RAYE MCKINLEY SUBDIVISION

APPLICATION NUMBER 12 DATE April 15, 2010

REQUEST _____ Subdivision _____

DETAIL SITE PLAN

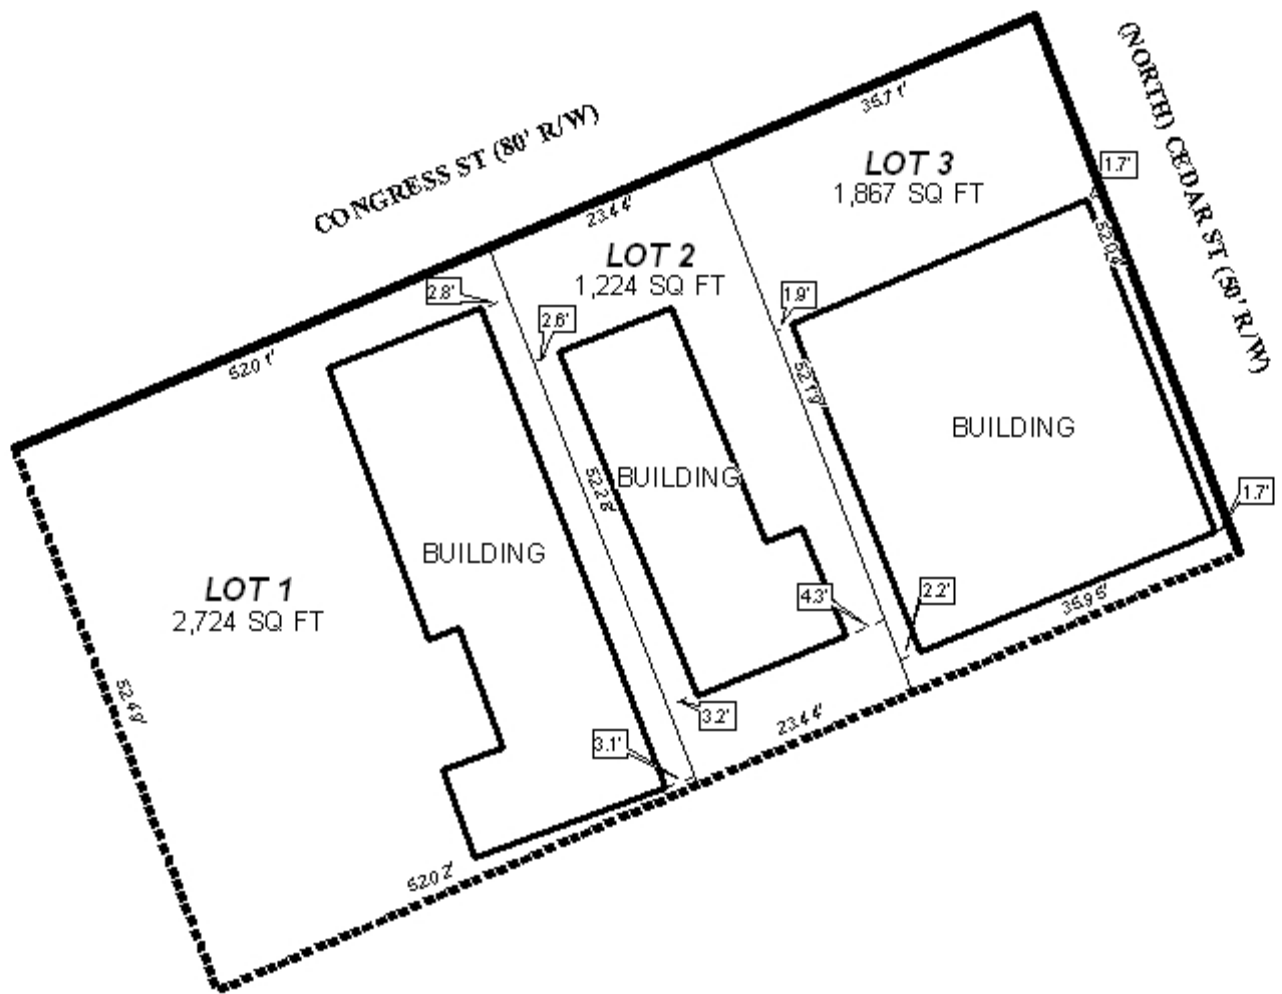
The proposed Lots 1 and 2, as depicted, do not meet the minimum size and frontage requirements as regulated by section V.D.2. the Subdivision Regulations. The proposed Lot 3 meets the public right-of-way frontage requirement, but does not meet the minimum size requirements.

The Subdivision Regulations require at least 60 feet of width at the minimum building setback line and a minimum area of 7,200 square feet. The proposed Lot 1 is depicted with 52.01 feet of frontage and an area of 2,724 feet; the proposed Lot 2 is depicted with 23.44 feet of frontage and an area of 1,224 square feet; and a the proposed Lot 3 is depicted with 87.75 feet of frontage (split between frontages on two sides) and an area of 1,867 square feet.

Additionally, it should be noted that this property is zoned B-4, which requires front, side and rear yards of zero or five feet. As such, this subdivision would create zoning setback violations, as existing buildings are depicted with proposed setbacks of as little as 1.9 feet.

Based upon the preceding, the application is recommended for denial for the following reasons:

- 1) the lots do not comply with Section V.D.2. of the Subdivision Regulations; and
- 2) the subdivision would create violations of the Zoning Ordinance.
